5201 42ND AVE S

SDCI Project# 3035730-LU, 3035987-EG

Design Recommendation Meeting
March 22, 2022

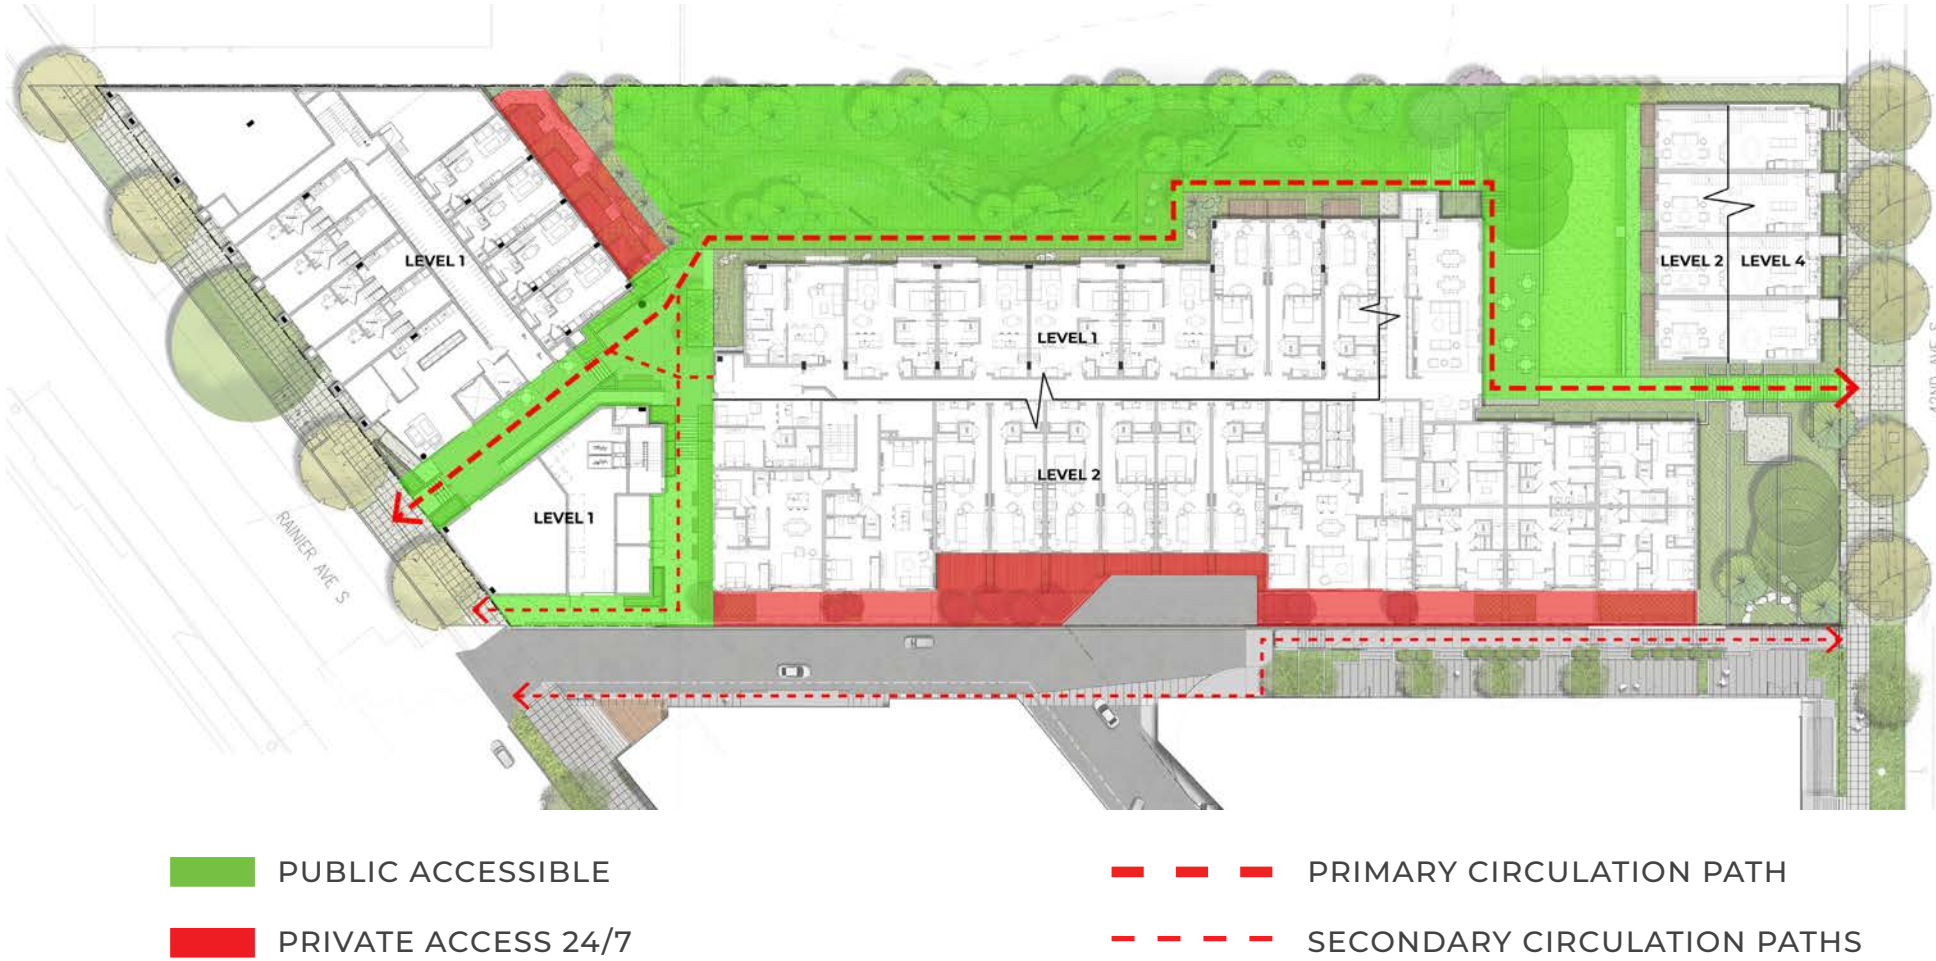
Cited Guidelines	Board Recommendation
PL1.B PL2.A PL2.B PL2.D PL3.B DC3.B.1	“the Board expects the design team to demonstrate how the design has evolved to clarify site circulation within the project in terms of dedicated public-only areas, common residential walkways/open spaces, private residential walkways/open spaces, universal accessibility (widened ramp/stairs), site security and privacy and wayfinding.”

As shown in the diagrams on the right, a significant portion of the site will remain accessible to the public, including a new public east-west connection between 42nd Ave. and Rainier Ave. This connection is a response to both public comments received and the need for project residents to easily access both Rainier Ave. and 42nd Ave. on foot.

The site circulation runs adjacent to ground level units where security is a concern. In response, landscape buffers are provided between paths and all ground floor units. A large number of units at all levels have windows looking out on the circulation path, providing resident eyes on these pathways to aid with security. The building will be equipped with security cameras after hours.

At Bldg. A, a vertical facade setback above the breezeway entry and highly visible entry signage helps with wayfinding for visitors. At Bldg. B, the entry to the site staircase at 42nd Ave. provides a direct view down to the Bldg. B entry at the courtyard below.

For those accessing Bldg. A from the Bldg. B parking garage, the west exit out of the garage leads directly to the Bldg. A breezeway, which leads to the building entry.

A material change and vertical building articulation occurs directly above the main breezeway and lobby entry on Rainier Ave. along with project signage.

RAINIER AVE COMMERCIAL SPACE ENTRY
LOCATED ALONG BREEZEWAY

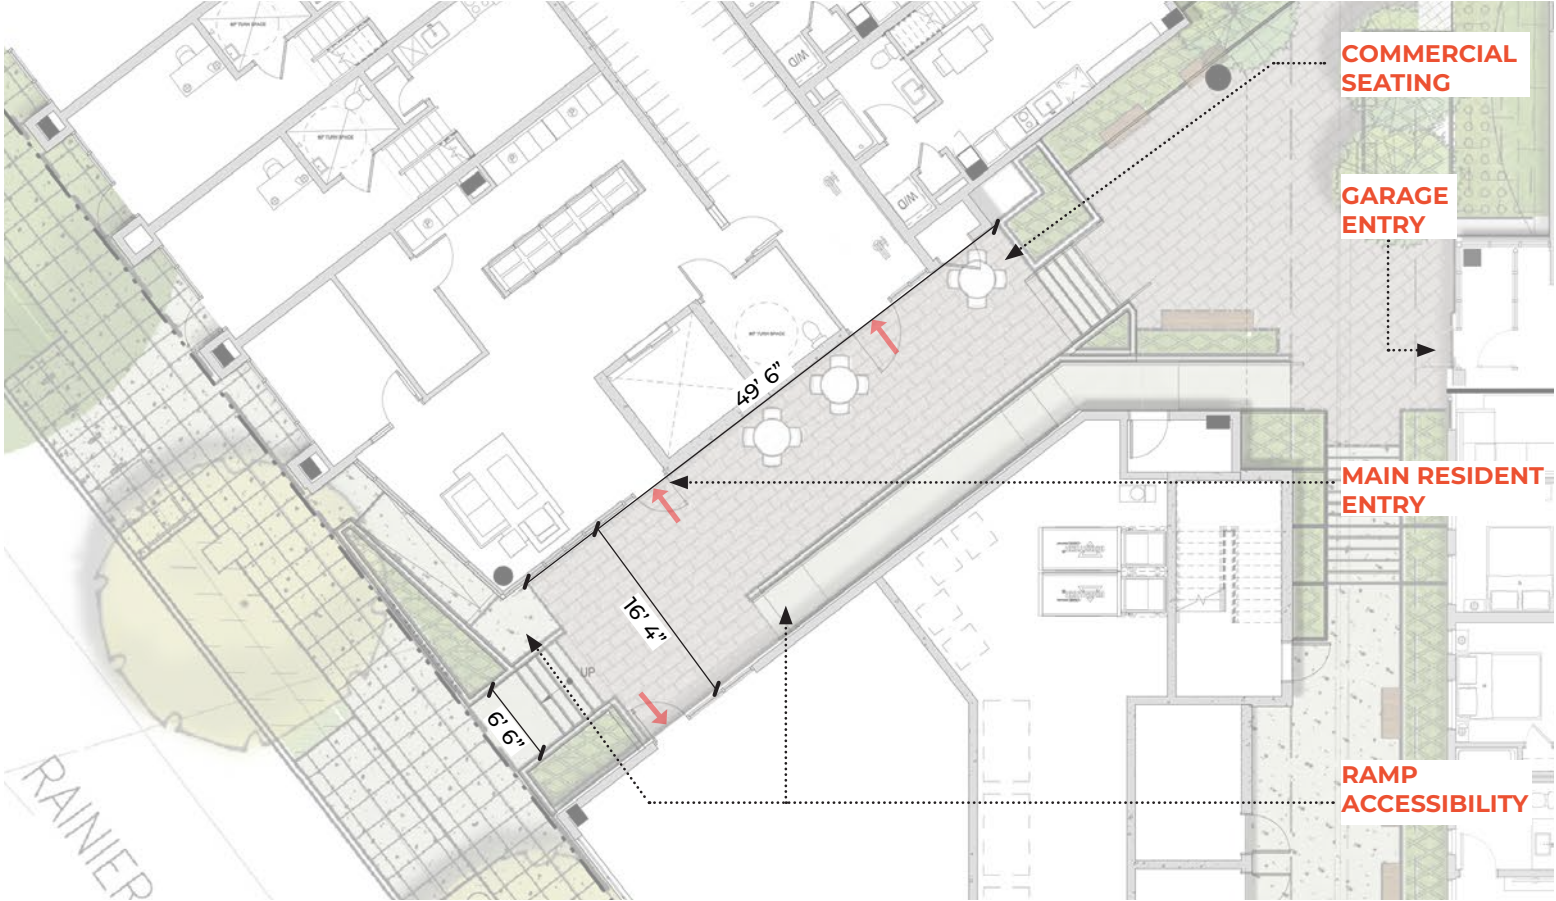
Cited Guidelines	Board Recommendation
CS3.A CS3.B	"The Board requested the applicant examine locating and arranging the ground-related commercial uses/entries along Rainier Avenue South in manner that could engage the breezeway entrance and accommodate ancillary activities (seating, etc.) to activate the public terrace area within the site."

The design team also reviewed the locations of building entries and program elements along the Building A breezeway in response to this guidance. The location of the Building A main residential lobby, bike parking, and one of the commercial spaces have had their entries located along the breezeway. Seating is provided within the breezeway as well as at the interior public terrace to encourage people to sit or rest instead of simply passing through. Landscaping and ramp accessibility is provided both at the breezeway entrance at Rainier Ave. and the public terrace.
